**Utah Lake Water Quality Study
Science Panel Comments Regarding
Wasatch Front Water Quality Council's Atmospheric Deposition Study**

We've appreciated the opportunity to have informal discussions with the Wasatch Front Water Quality Council over the course of multiple Science Panel meetings and calls. Provided below is the Science Panel's effort to provide formal comments on the draft Atmospheric Deposition Work Plan provided and presented thus far. We look forward to continuing to discuss refinements as appropriate.

8) Examples used in the proposal should be clearly relevant to Utah Lake:

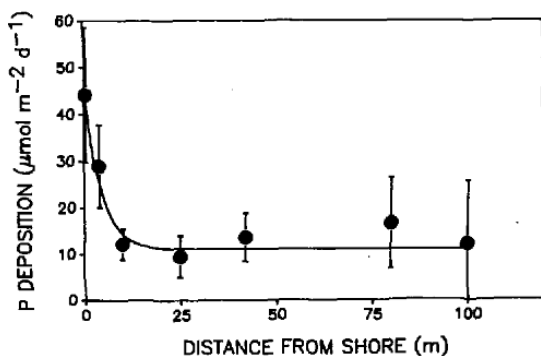
This is not always the case, for example Utah Lake should not be compared to a small forested New Hampshire Lake. Mirror Lake in New Hampshire is 15 ha compared to Utah Lake's 38,450 ha. The ratio of shoreline to lake area is much greater for Mirror Lake, and therefore so would be the influence of terrestrial deposition of bugs and vegetation to the lake. What is not included in the proposal is that the Cole et al paper shows a rapid drop off in deposition rate at just 10m, which is probably accurate for large fragments of vegetation emerging from a forest canopy, but not likely applicable to the types of local contamination around Utah Lake. The proposal should cite relevant literature examining extinction rates for deposition across lakes.

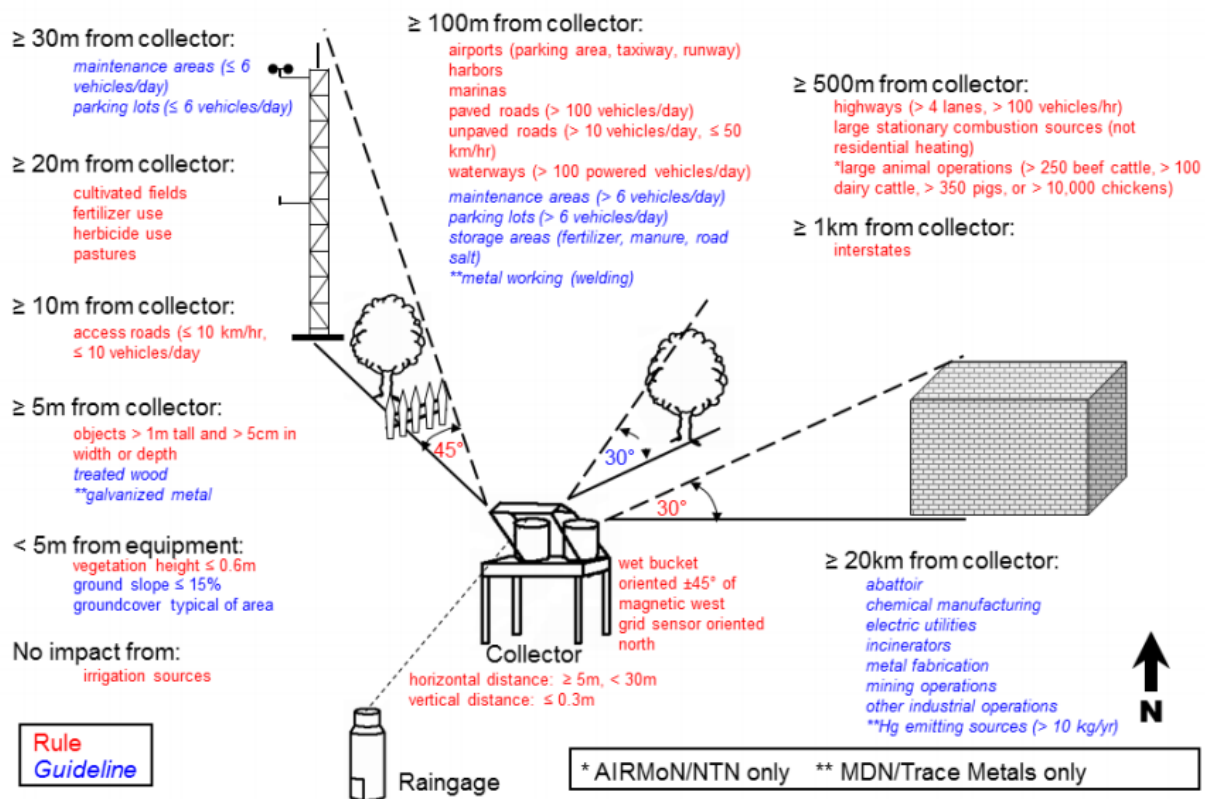
The proposal cites unpublished literature indicating P concentrations in deposition that are extremely high (0.8 mg-P/L). No information is given as to the state of the samples

and whether they were contaminated by bugs or bird feces, or what actions were taken to avoid or remove contaminated samples. These types of samplers often have bug and bird contamination and including these results is misleading. Given that P does not have a stable gaseous form, and is thus primarily transported in particulate form, concentrations in precipitation are not expected to be large. Further, there have been no dust leaching studies anywhere in the world that would suggest a rain storm could produce values as high as 0.798 mg/L. The proposal states that the values may be compromised by agriculture or construction, but still goes on to inappropriately extrapolate these values across the entire lake arriving at a deposition rate higher than has been observed anywhere else in the world (110 tons to Utah Lake per year) and is in direct conflict with the examples provided in the proposal introduction (see point 7).
